W.A. TROW & ASSOC. LTD.			
FOUNDATION INVESTIGATION			
PROPOSED CROSSING AT HIGHWAY NO 401 E.B.L. LINE 'G' AND ROCKPORT RD. LINE 'A'			
PROJECT NO 1967	W.P. NO 174-61	DATE NOV. 1962.	DWG. 1.

ROCKPORT RD OVERPASS  
E. B. L.

SUBJECT: W.P. 174-61-1, Bridge Site 17-153  
Rockport Rd. E.B.L. Overpass  
Hwy. #401 - District #8.

Re: Foundation Conditions - Rockport Road Overpass  
Hwy. 401, W.P. 174-61 - 1

TRACING	CHECK	#20	DRAWING
DATE 20 FEB 63		516	NUMBER D-5233-1

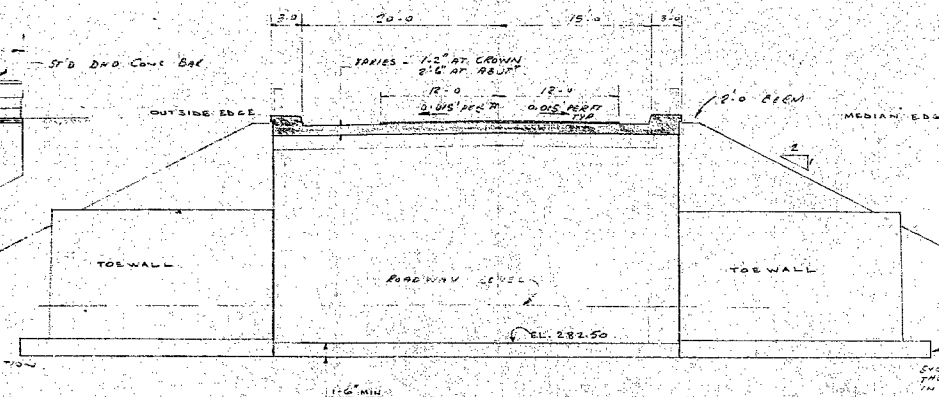
Enclosed please find one copy of the preliminary plan D-5233-1 for the above structure.

The designer appears to have complied with the requirements of the foundation report but we would appreciate any comments you wish to make.

consulted with Mr. Trow and Associates regarding the above mentioned structure. The said consultation informed that the differential settlements between the two footings (one on bedrock and the other founded clay) will be in the order of 1 to 1 1/2 inches. Ted Hanson of Bridge office believes that the differential movements will be within tolerable limits. Informed Mr. A. Watt by phone, the above mentioned facts.
